## Architectural Review Board Staff Report

**Project Type:** Amended Architectural Elevations

**Description:** **Four Seasons Plaza, Brunswick Zone:** Amended Architectural Elevations and Statement of Design for a 3.46 acre tract of land zoned “PC” Planned Commercial located on the south side of Olive Blvd., west of Highland Park Dr.

Figure 4: Proposed Screening

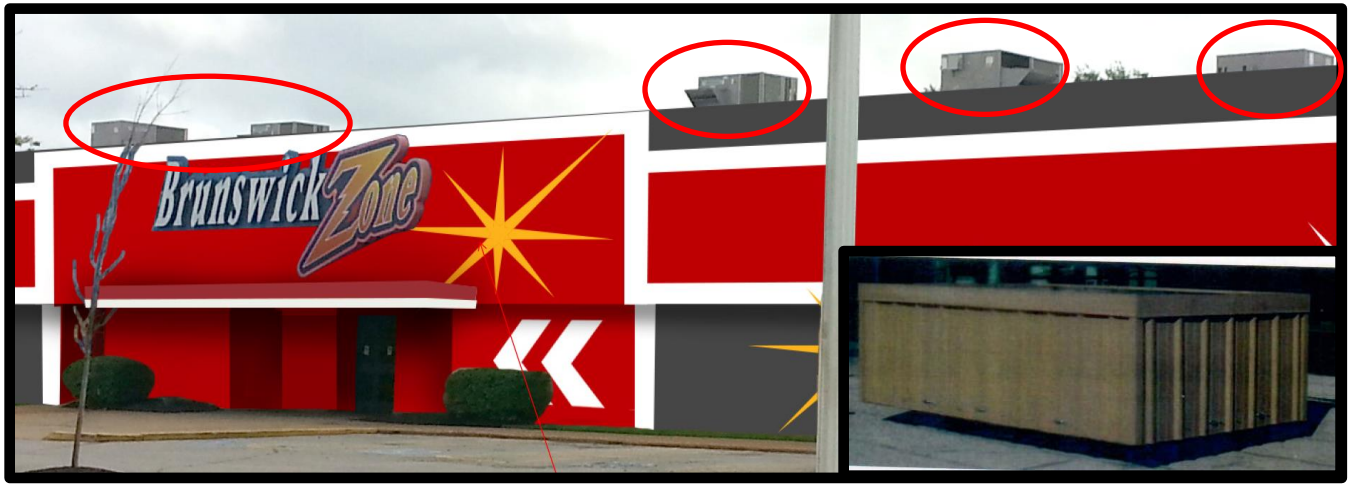
*Provide architectural details particularly on façades at street level* – No modifications have been made specifically to the architectural details at street level as all the updates on the facades are painting. The addition of the “Charcoal Gray” roof top screening on 8 equipment units is in a similar color to the “Grizzle Gray” painted walls. Currently there is no screening present on the roof top equipment.

Screen rooftop equipment on all visible sides with materials that are an integral part of the architecture. Parapet walls or screen walls shall be treated as an integral part of the architecture and shall not visually weaken the design of the structure. – The applicant is proposing to install three-sided rooftop screening for 8 equipment units currently on the roof which are visible from the street. There are 3 units not visible from the street, but visible from the top by an apartment complex behind the bowling center that are to be unchanged. The rooftop equipment screening will be in similar color to the exterior walls as mentioned above in charcoal gray.

Chesterfield Front and Right Side Elevations

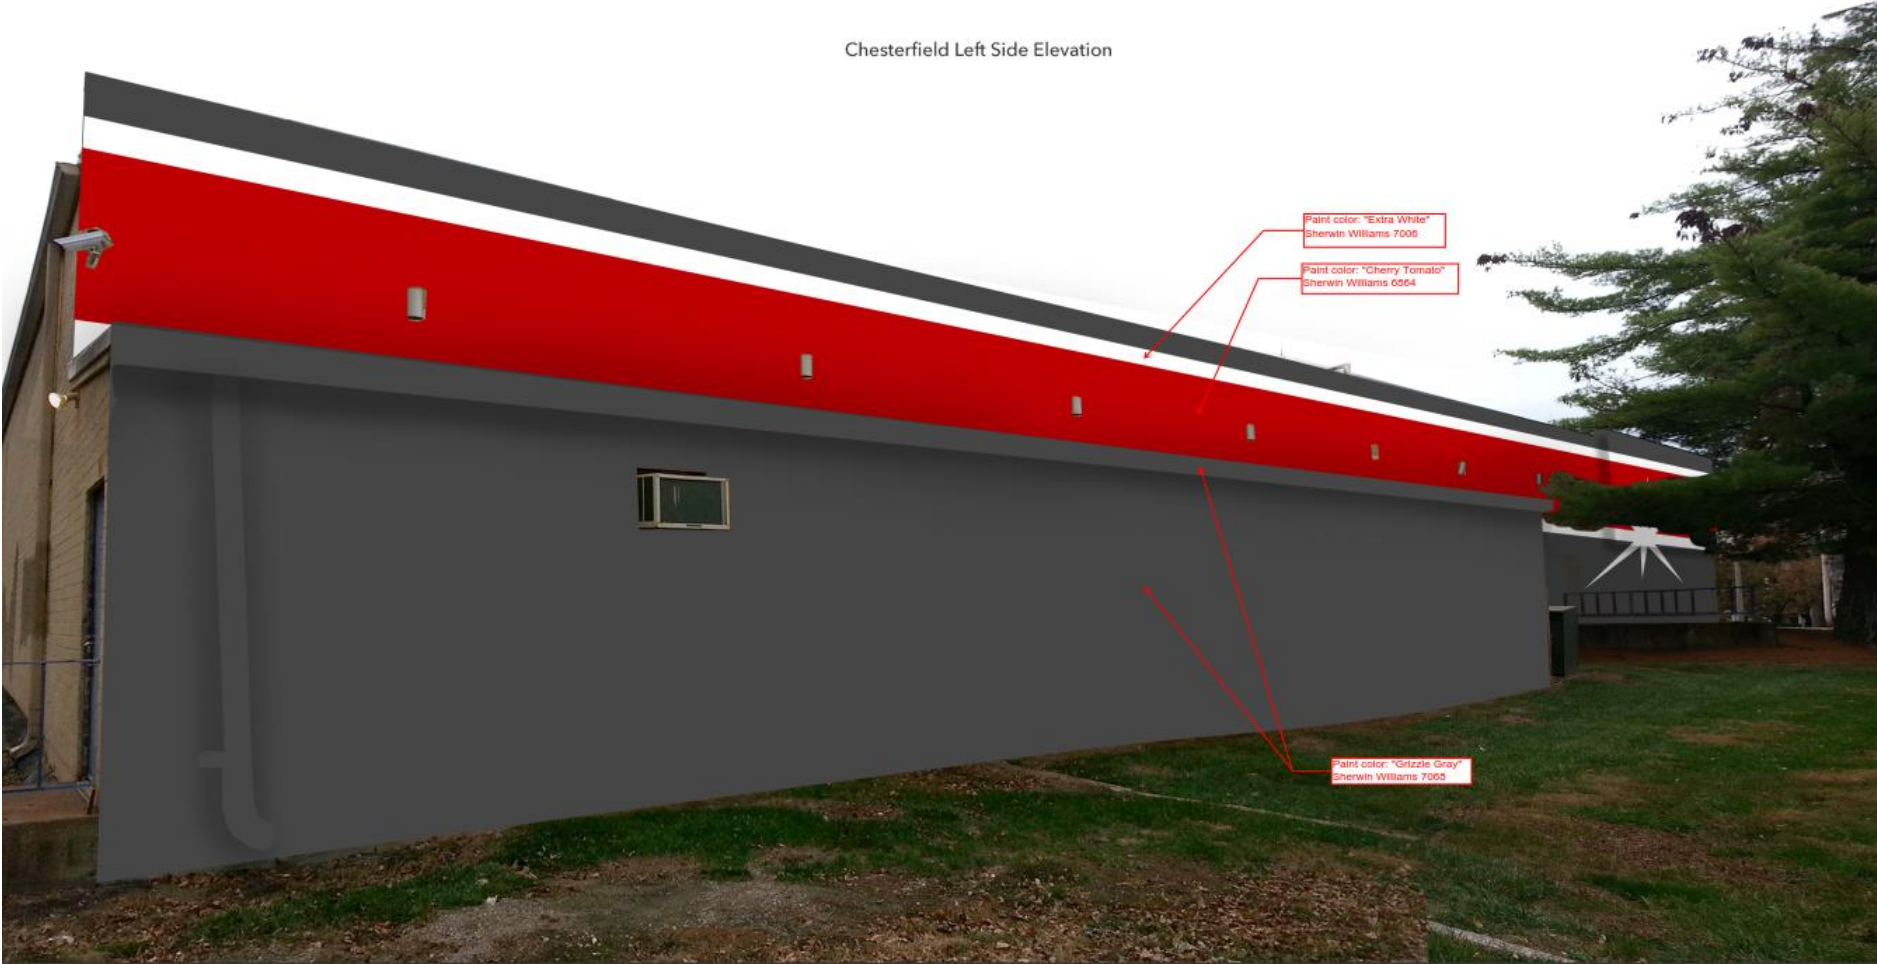
The proposed building colors are sharp in contrast. The color scheme is unique in relation to the adjacent buildings and properties.
